Subject: Collin County Healthcare Facility, Parking Garage, and Medical Examiners  
PCO No. 093; RFI #326 X-Ray and Lodox Equipment Room Layout Clarification

Issue No. 093 - RFI #326 X-Ray and Lodox Equipment Room Layout CI      Amount

## RFI #326: ME - X-Ray and Lodox Equipment Room Layout Clarification

DRAWN BY: DAVE HENRY	SCALE: 1/4" = 1'-0"
DATE: 06/14/2016	SHEET: E-1
FILE NAME: USL160613

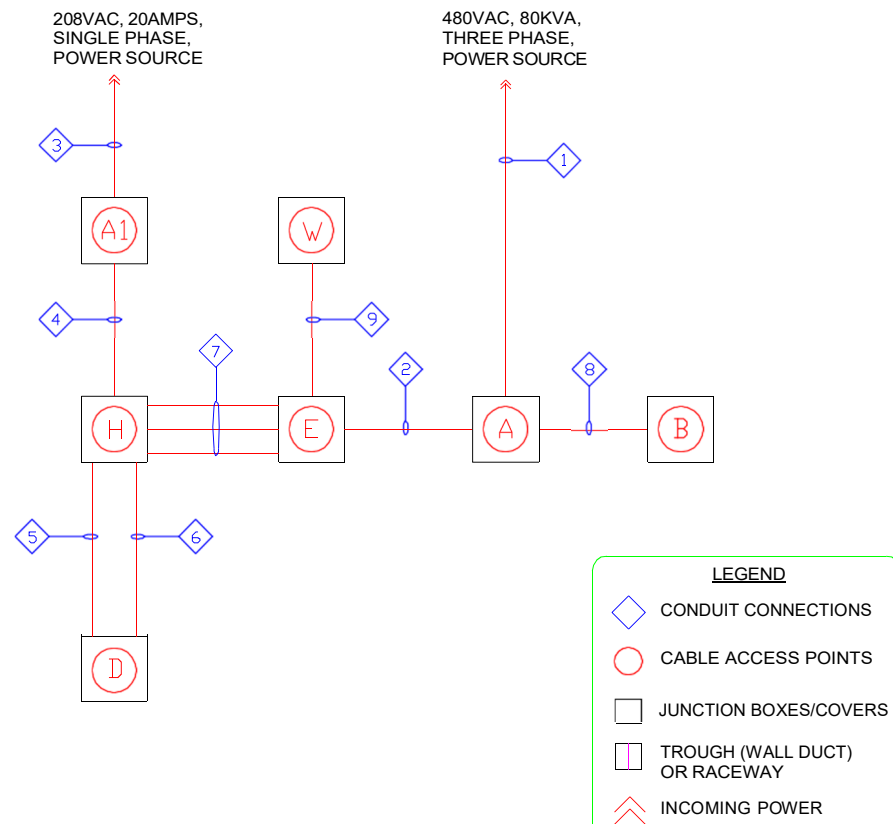
CIRCUIT BREAKER GETS INSTALLED BEHIND BRYANT AND I TALKED ABOUT THIS AND LOOKED THROUGH SHOP DRAWINGS FOR ANOTHER LODOX INSTALL. THE CIRCUIT BREAKER IN QUESTION GOES OVER BY THE WORKSTATION.

MANUFACTURER SEEMS TO INDICATE THE NEED TO ONLY SHUNT TRIP POWER TO THE X-RAY GEN POWER. SUMMIT'S DESIGN SHOWS POWER BEING KILLED TO BOTH THIS AND THE X-RAY STAND POWER. THE LATER STILL SEEMS CORRECT TO ME. EC TO COORDINATE THIS WITH THE MANUFACTURER AND INSTALL PER THEIR GUIDELINES.

POWER FOR THE PORTABLE X-RAY MACHINE IS NOT SHOWN HERE BUT NEEDS TO BE COORDINATED WITH THE LODOX REQUIREMENTS. THIS IS SHOWN AS ME9 ON THE ELECTRICAL DRAWINGS.

MANUFACTURER CALLS FOR QUAD HERE INSTEAD OF DUPLEX

TECHNOLOGY SYSTEMS INSTALLER AND TECHNOLOGY DESIGN NEED TO COORDINATE THEIR REQUIREMENTS, EC TO PROVIDE ALL PATHWAYS FOR LV CABLING.
